City of Highland Park  
Historic Preservation Commission  
**Thursday, August 13, 2015**  
1707 St. Johns Avenue, City Hall  
**7:30 p.m.**

**REGULAR MEETING AGENDA**

# Application for a Certificate of Appropriateness

TO:	The Historic Preservation Commission
DATE:	August 13, 2015
FROM:	Andy Cross, Planner II
SUBJECT:	Modification to the Historic House

**Figure 2: Proposed front elevation**

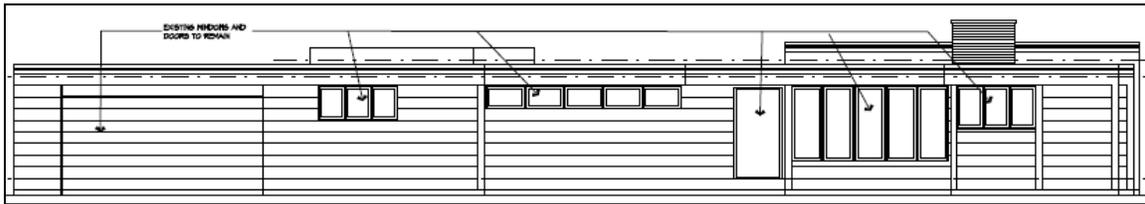
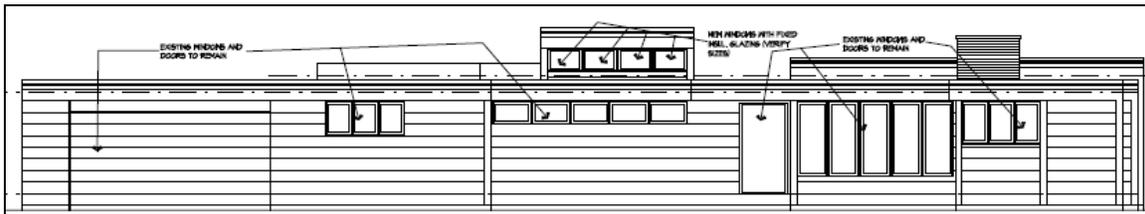
*The proposed modification will have an impact on the roofline of the house.*

Staff recommends that the Historic Preservation Commission discuss the proposed alteration to the Mildred Goodstein house and whether the standards listed above are satisfied. The Commission may approve the plans, or recommend changes to the plans to meet the standards listed above.
